MEMORANDUM

SUMMARY OF:

P960013/S068/A001 Tendril Leads Helix-Shaft Subassembly modification
P950022/S079/A001 Durata Leads Helix-Shaft Subassembly modification
St. Jude Medical

Figure 3: 1488 Helix-Shaft Assembly and Proposed Helix-Shaft Assembly

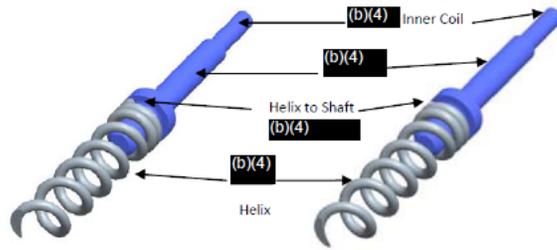
The helix design is not new, nor is the material as it is used on the current market approved Model 1488 lead. Per the sponsor, the Tendril Model 1488 lead approved under P960013/S07 on March 7, 2000, has demonstrated a long history of proven reliability. The Model 1488 lead and the proposed helix design both incorporate a (b)(4). The product specification and welding requirements remain unchanged with the proposed helix-shaft design as demonstrated by the (b)(4) testing done in qualification testing. The shaft design is not new, nor is the material as it is used on the current market approved Model 1488 lead. As shown in Figure 3 below, (b)(4) is used in the same application in both the Model 1488 lead and the proposed assembly.

For both the Model 1488 assembly and proposed helix-shaft assembly, the connection design on the proximal end of the shaft includes an (b)(4). In addition, the connection on the distal end of the shaft includes an (b)(4). The product specification and welding requirements remain unchanged with the proposed helix-shaft design.

In her original review memo dated Jan 19, 2012, the Mechanical Reviewer reviewed the proposed design changes and identified a major deficiency which requested historical performance data for the Model 1488 helix design.

In **Amendment A001**, the sponsor responded to the deficiency. The response was reviewed by the Mechanical Reviewer. During the course of the review, additional questions were interactively discussed. The reviewer found the responses acceptable.
